**Request for Additional Information No. 384, Supplement 4 (4350, 4351, 4469, 4498,  
4527), Revision 0**

**U.S. EPR Standard Design Certification**

**Docket No. 52-020**

**Application Section: FSAR Chapter 3**

**Figure 3.08.04-11-1—Schematic of Typical Anchorage of Strainer or Basket to Concrete Floor**

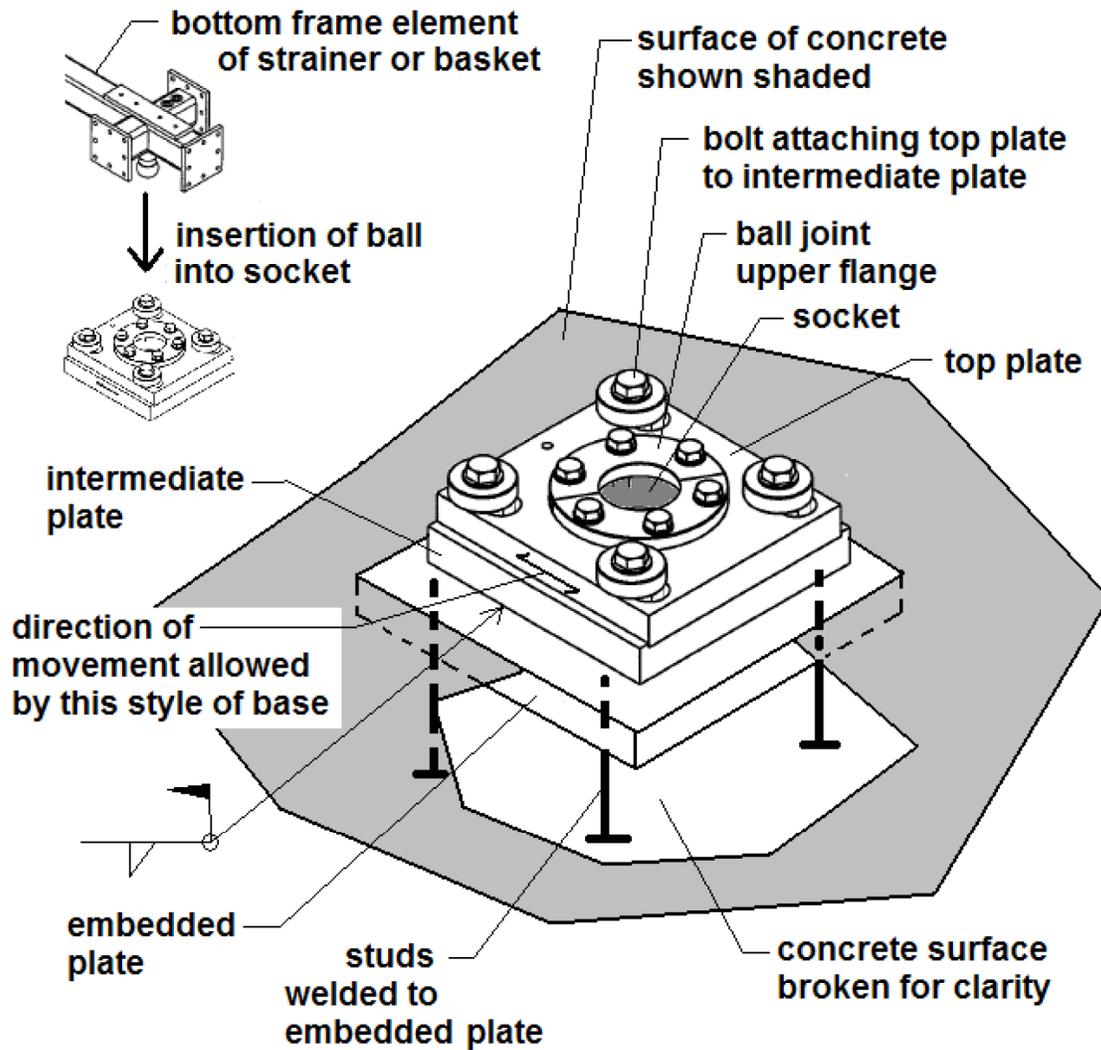
Consistent with SRP Section 3.8.4, the applicant has committed to use ANSI/AISC N690-1994, "Specification for the Design, Fabrication and Erection of Steel Safety-Related Structures for Nuclear Facilities," Supplement 2 (S2) based on allowable stress design methodology in the DCD submittal of the debris interceptor design. Regulatory Guide 1.84, Rev. 33, endorses ASME Code Case N-570-2, "Alternative Rules for Linear Piping and Linear Standard Supports for Class 1, 2, 3, and MC Section III, Division 1, Supplement 7," which approves N690-1994 including S2 as an alternative to ASME Code, Section III, Subsection NF. While the use of ANSI/AISC N-690 is acceptable to the staff, this code does not contain explicit guidance regarding the design of linear type supports, which will be employed in the strainer component design.

In its technical report of February 2008 (ANP-10293-U.S. EPR Design Features to address GSI-191) and in its response to NRC question 06.02.02-32 part (a) and (b), the applicant did not provide information regarding the wall and base mat supports and anchorage types, which will be used in the debris interceptor design.

In order for the staff to complete its review and evaluation of the structural integrity of the supports and anchorages as it relates to the abilities of the trash rack, retaining baskets and sump strainers to perform their intended functions, the staff requests that the applicant provide a description of the industry codes and standards applicable to the design and analysis of the supports and anchorages related to the aforementioned seismic category I structures. In addition, the applicant should describe how the structures would be connected and anchored to the concrete walls or base for the retaining baskets and the sump strainer.

The strainers, trash racks, and retention baskets will be anchored to the basemat at discrete locations using a ball and socket joint, which allows for free rotation to minimize thermal stresses. To further minimize thermal stresses, some of the anchorage points will also allow for sliding in one or two directions. Figure 3.08.04-11-1 illustrates a typical ball and socket joint at an anchorage point that allows for sliding in one direction. Similar configurations are used at anchorages that allow sliding in two directions and at those resisting movement in all three directions.

Each of the four strainers has six such anchorage points mounting the strainer frame to the basemat. Each of the two double compartment retention baskets has four anchorage points mounting the basket frame to the basemat, four anchorage points mounting the frame to the side wall, and two anchorage points mounting the top horizontal cross braces to the side wall. Each of the two single compartment retention baskets has at least eight anchorage points mounting the frame to the basemat and at least ten anchorage points mounting the frame to the two side walls. The anchorages to the side walls are similar to those shown in Figure 3.08.04-11-1. The anchorages are divided between those allowing for zero-, one-, and two-direction movement in a way that minimizes thermal stresses and still allows for the complete transfer of all forces to the concrete elements.

At the typical anchorage illustrated in Figure 3.08.04-11-1, a ball is mounted to a structural element that is part of the bolted assembly of the bottom frame of the strainer or basket. This ball is inserted into the socket of the base and held there by the split ball joint upper flanges that are bolted to the anchorage top plate that contains the socket. The top plate is bolted to the intermediate plate of the anchorage, which is field welded to the embedded plate that is anchored to the concrete by means of headed studs or other similar standard concrete anchors.

**Figure 3.08.04-12-1—Quadrant of Floor of Double Retention Basket**

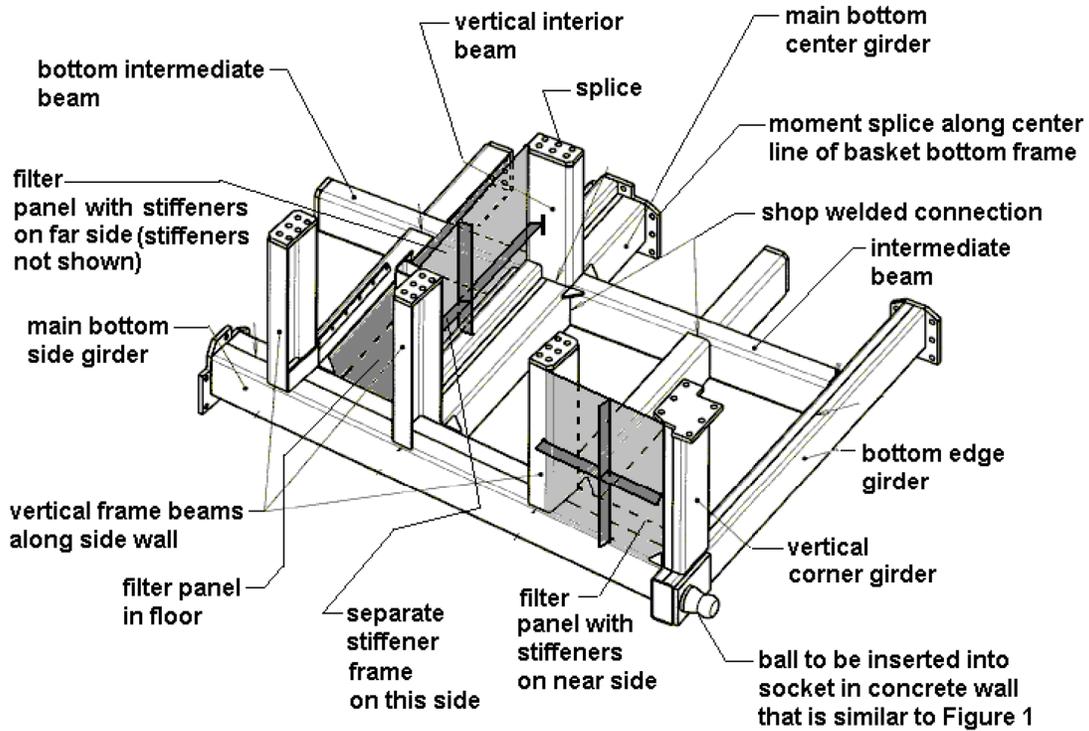
- a) A description of the methods and methodology which will be used for structural analysis of trash racks, retaining baskets and sump strainers;
- b) A description of the damping values, which will be used for the specified type of steel structures, used to construct the trash racks, retaining baskets and sump strainers. If these values are not consistent with the guidance provided in RG 1.61 described above, please provide a justification such that the staff can make a conclusion regarding whether the alternative damping values used provide an adequate level of safety such that the structural integrity of the aforementioned structures is not compromised in a way that inhibits their ability to perform their intended safety functions,

- c) A description of the structural elements of the debris interceptor components on which the differential pressure loadings are applied including a discussion of whether the differential pressure loadings will consider credit for the perforated screen surfaces; and,

- d) A description of the design features, which may be used to accommodate the thermal expansion movements, associated with the maximum design temperature based on the post-LOCA containment environment and pool temperatures. If none of these features are

- a) The basic approach for the double retention baskets is illustrated in Figure 3.08.04-12-1, which illustrates a quadrant of the bottom frame for this basket, and in Figure 3.08.04-12-2, which illustrates a typical filter panel for the wall of this basket.

- c) Figure 3.08.04-12-2 illustrates a typical filter panel for the wall of a double retention basket, and Figure 3.08.04-12-1 illustrates how such panels are configured in the walls and floor of the basket. Panels on the floors, walls, and roofs (as applicable) of the other baskets and sump strainers have a similar layout. The filter panels are the components that receive the direct static and dynamic pressures from the fluids inside and outside the basket. These pressures may be different inside and outside the basket, resulting in differential pressure. All states of pressure loading will be evaluated to determine the maximum value of this differential loading in both the inward and outward direction. The filter panels will then be evaluated for these pressures, with the inside stiffeners assisting in resisting pressures that are directed inward, and the outside stiffeners assisting in the resistance to pressures that are directed outward. If these devices are not plugged with debris, the pressures would be applied only on the exposed area of the wire cloth mesh. However, if functional testing reveals that these devices will be plugged with debris, then no reduction for the open area will be considered, and the pressures will be applied to the full area that is bounded by the plane of the wire cloth mesh.

**Figure 3.08.04-14-1—Attachment of Wire Cloth to Boundary of Panel**

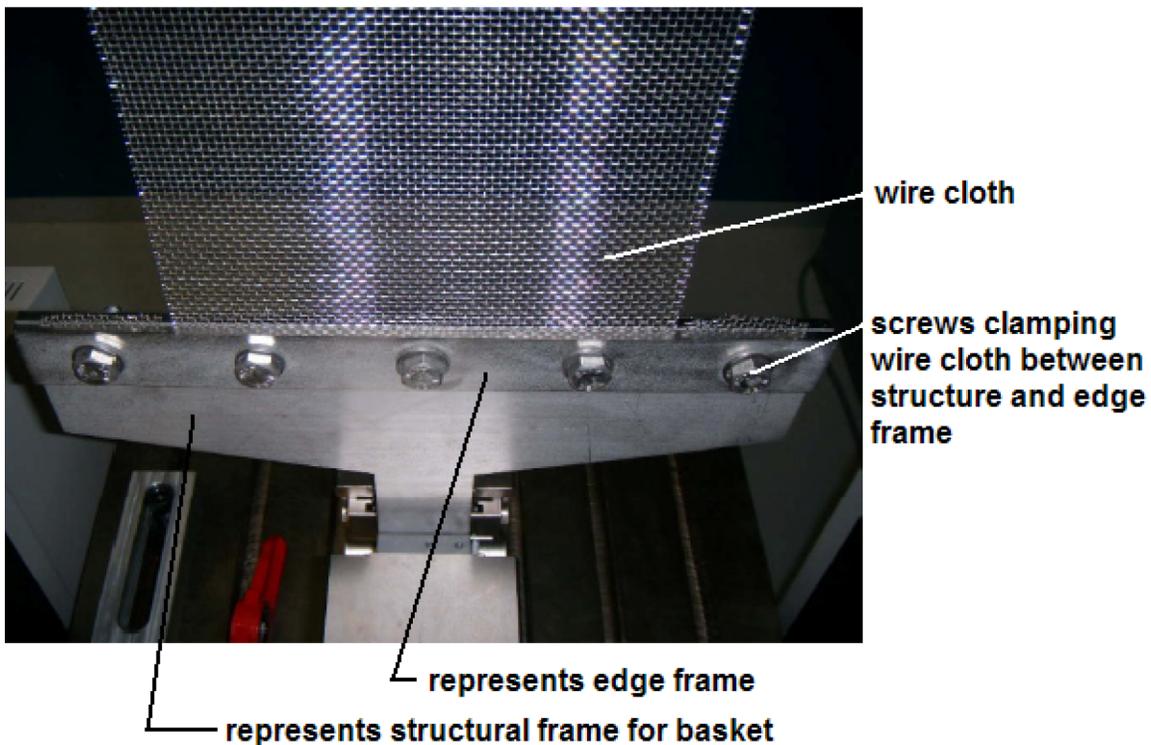
- a) Describe the design of the joint and attachments of the screen, and how the screens are attached to the sump strainer to preclude the possibility of debris bypassing the screening, and
- b) Provide a justification for assuming that the screens will remain undamaged and there will be no gaps and breaches between the screens and the structural members of the debris interceptor components, such that the operability of the recirculation core-cooling sump pump is not affected during LOCA or SSE events.

Figure 3.08.04-14-1 illustrates a representative design of the connection of the wire cloth to the boundary elements corresponding to a filter panel. This figure is from a model having its various components cut away for clarity and does not reflect the continuity of these components that would occur in the actual device.
